UNITED STATES PATENT AND TRADEMARK OFFICE

Office Action Summary

10/575,499

DETAILED ACTION

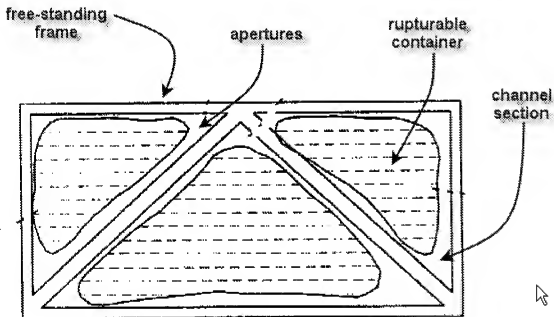
Parkes discloses a blast mitigation structure comprising one or more rigid free-standing frames (see figure above) of one or more channel section (see figure above), the or each frame being adapted to receive in the or each channel, in use, one or more

rupturable containers (32, See figure above) adapted to contain liquid (Column 4, lines 3-4) to thereby form a protective tunnel (Fig.5).

Regarding claim 5 as best understood, wherein the or each rigid free-standing frame has apertures (see figure above) therein such that the exposed parts of the or each rupturable container are in the direct path of an explosion.

Regarding claim 12 as best understood, further comprising one or more rupturable containers containing liquid (32, see Figure above), the blast mitigation

Regarding claim 13 as best understood, a kit of parts capable of providing a blast mitigation structure according to claim 12 (see rejection above), the kit of parts comprising one or more rupturable containers (See figure above) adapted to contain liquid and one of more rigid free-standing frames (See figure above) of one or more channel section (See figure above), the or each frame being adapted to receive in the or each channel, in use, said one or more rupturable containers (See figure above).
